SUBJECT: NuScale Power, LLC Response to NRC Request for Additional Information No. 164 (eRAI No. 8935) on the NuScale Design Certification Application

NuScale Response to NRC Request for Additional Information eRAI No. 8935

eRAI No.: 8935

NRC Question No.: 03.07.02-23

Figure 5-21. RXB - Uncombined North-South (Y) ISRS, Node 30350, El. 181', Roof Center, Capitola Input.

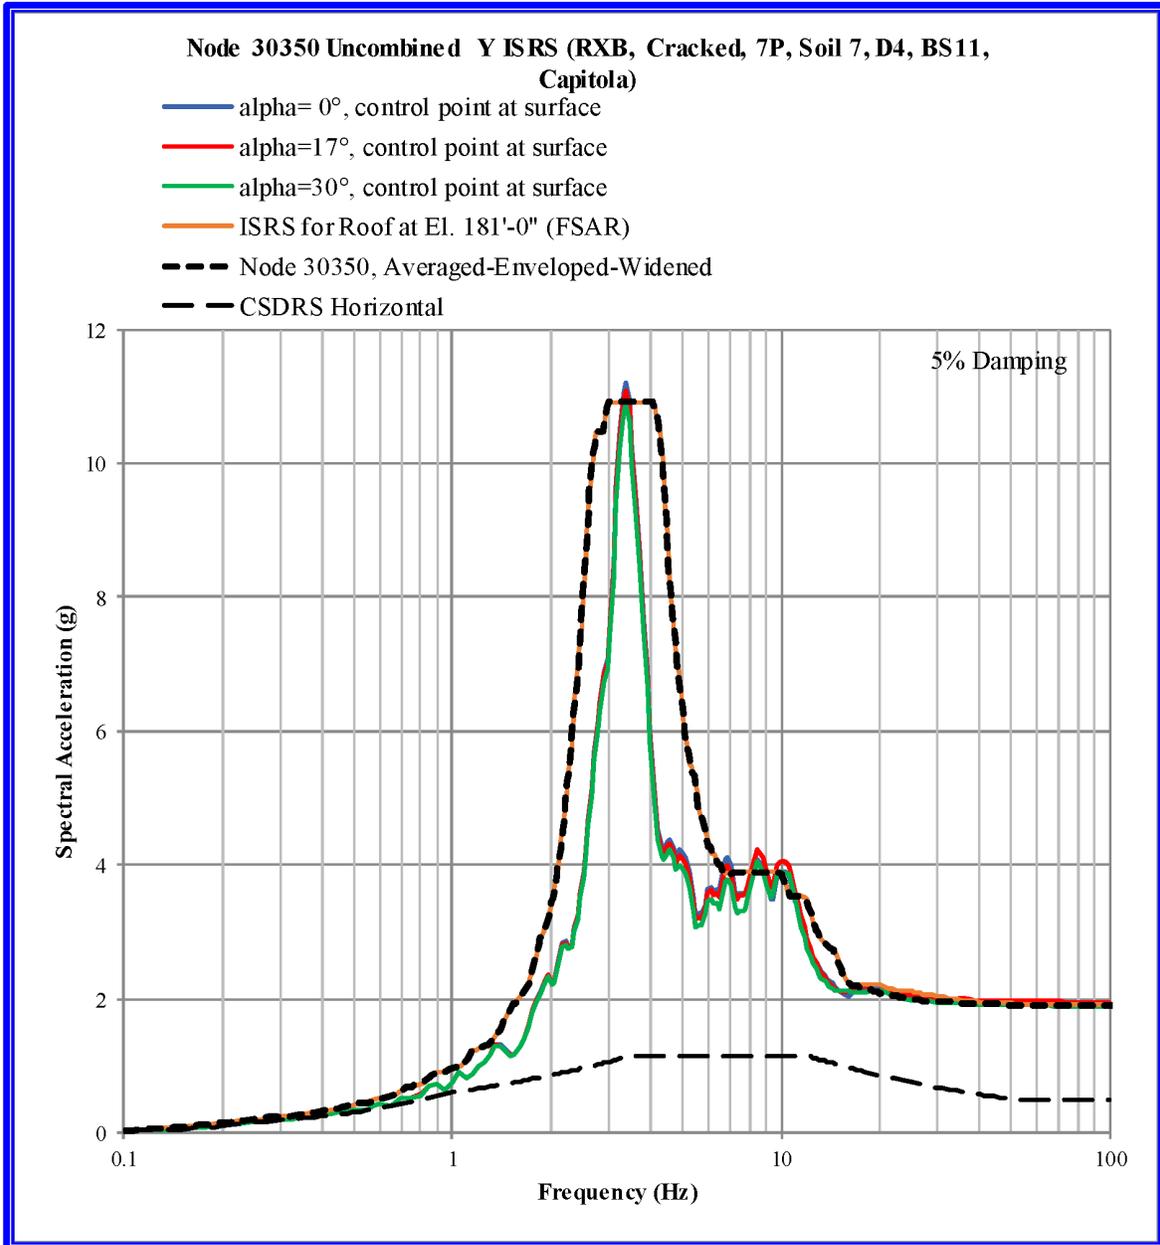
In Figure 5-21, the floor ISRS curve envelopes the $\alpha=17^\circ$ and $\alpha=30^\circ$ curves, except for peaks at 3.3 Hz, 7 Hz, 8.5 Hz, and 10 Hz. When the average ISRS of the five time histories is used, the exceedances are expected to be smaller.

Figure 5-22. RXB - Uncombined Vertical (Z) ISRS, Node 30350, El. 181', Roof Center, Capitola Input.

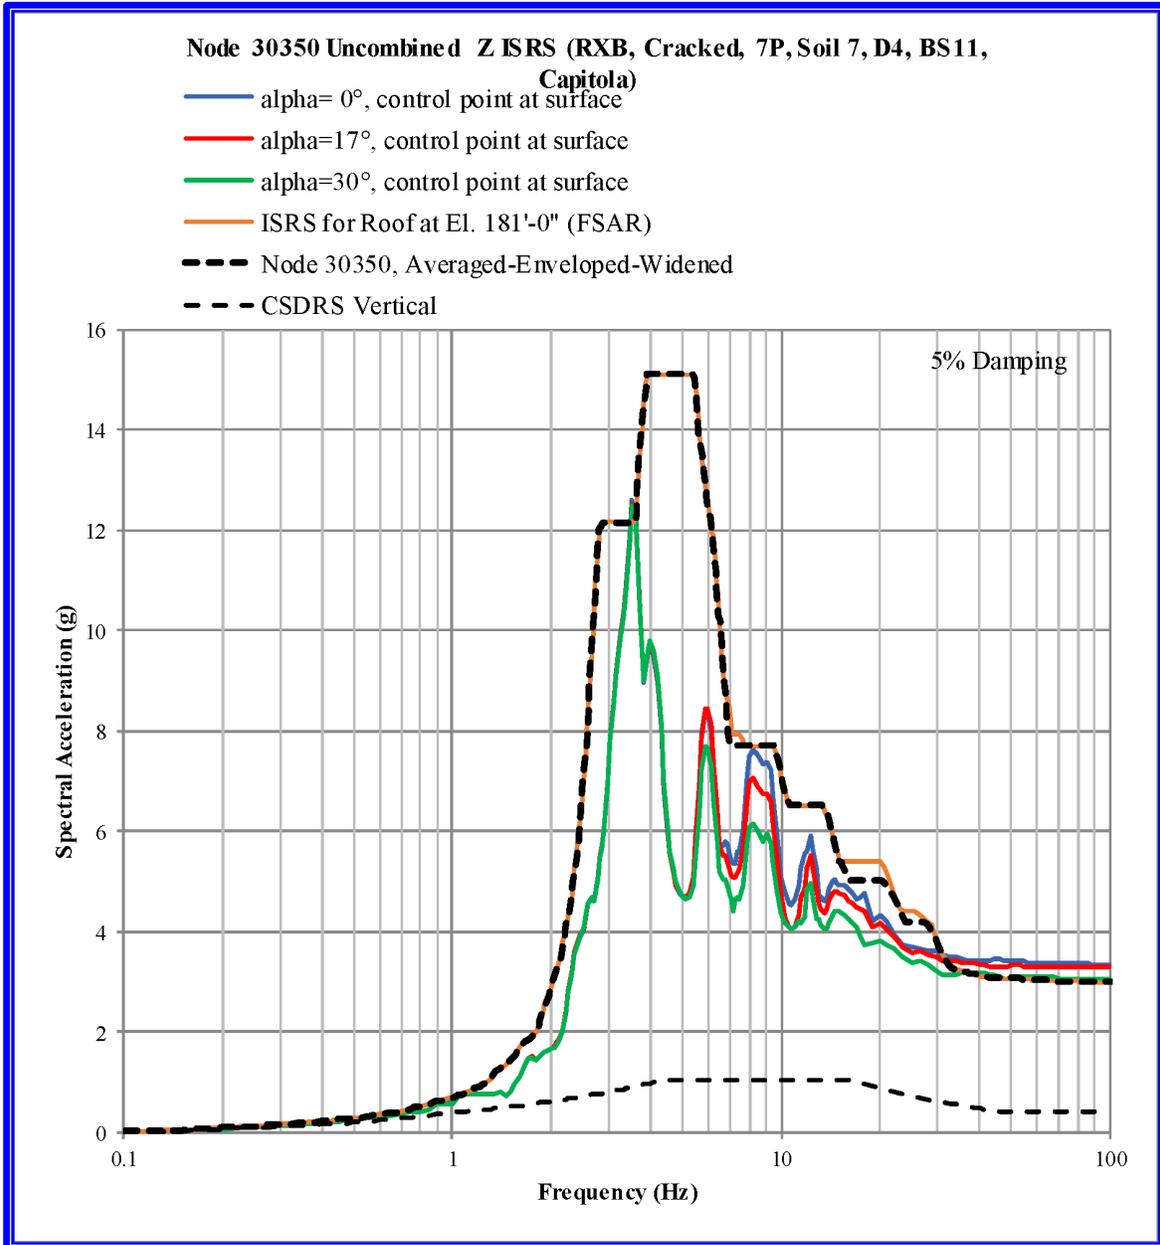
In Figure 5-22, the floor ISRS curve envelopes the $\alpha=17^\circ$ and $\alpha=30^\circ$ curves, except for peaks at 3.5 Hz and from 30 to 100 Hz. When the average ISRS of the five time histories is used, the exceedances are expected to be smaller.

Figure 3.7.2-149: Non-Vertically Propagating Seismic Wave RXB Sensitivity Analysis Cases

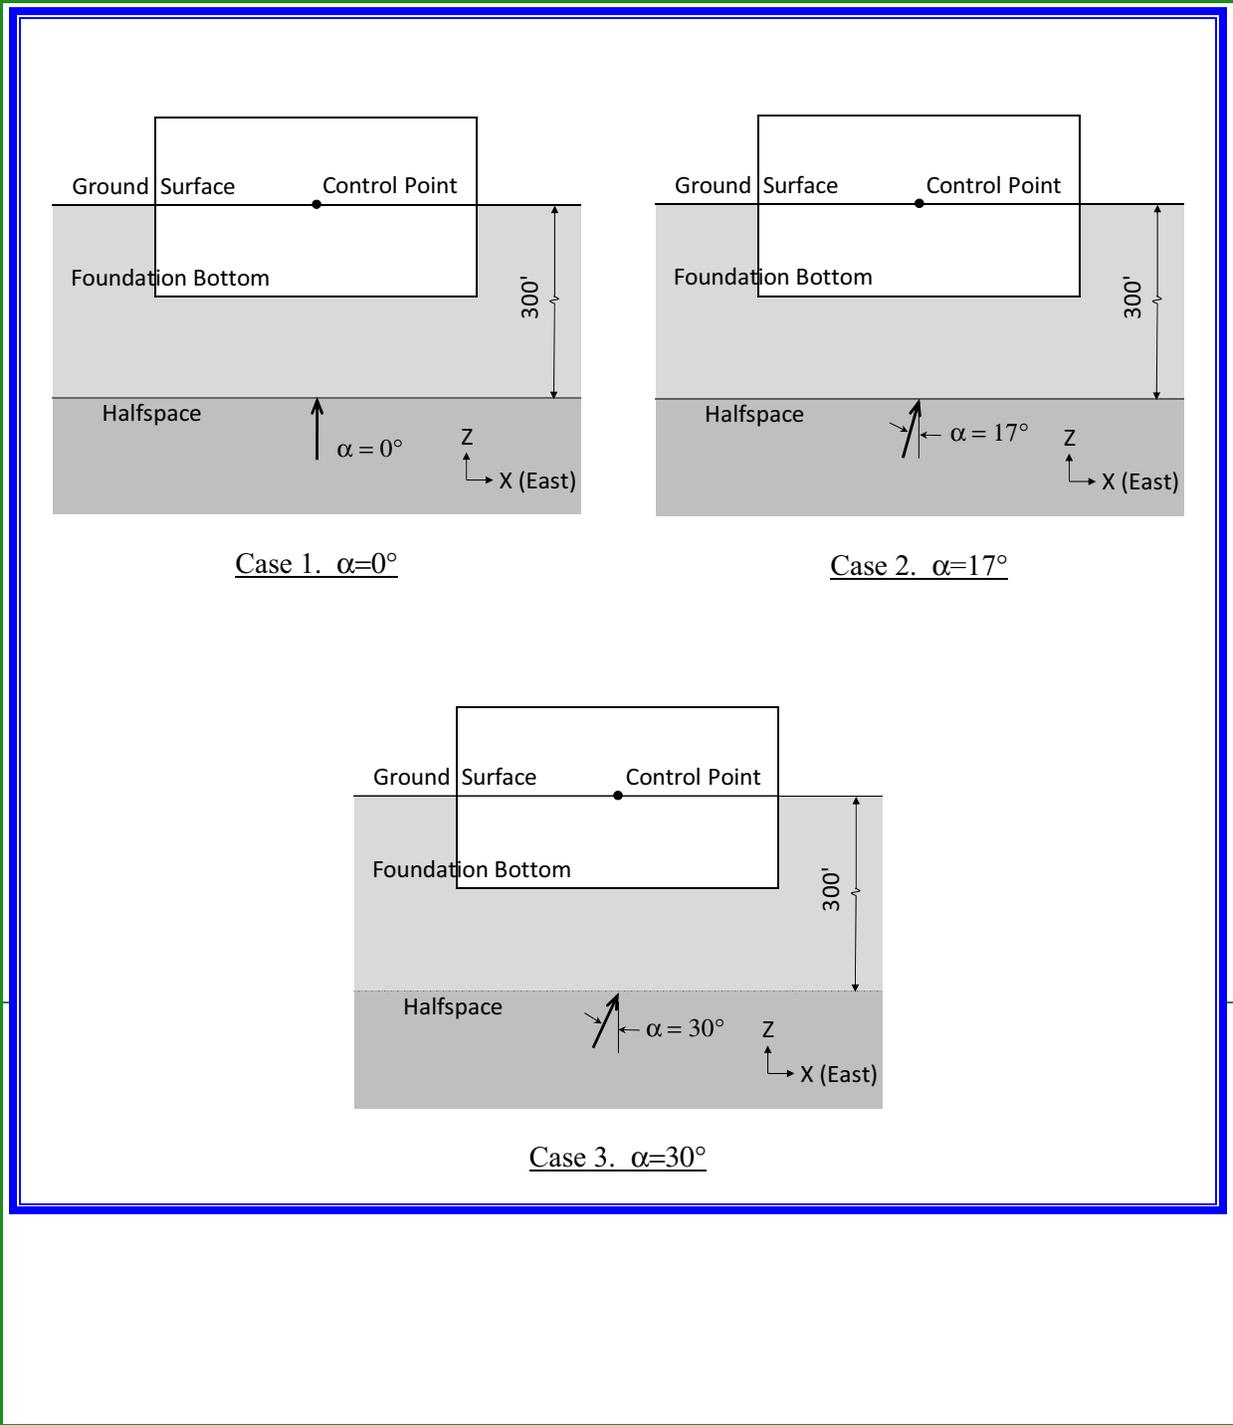
Analyses were performed and results compared for the following angles of incidence, α , where α is measured from the vertical axis (see Figure 3.7.2-149):

FSAR Tier 2, Section 3.7.2.1.1.3 and FSAR Tier 2, Figures 3.7.2-149 through 3.7.2-155 have been revised as described in the response above and as shown in the markup provided in this response.
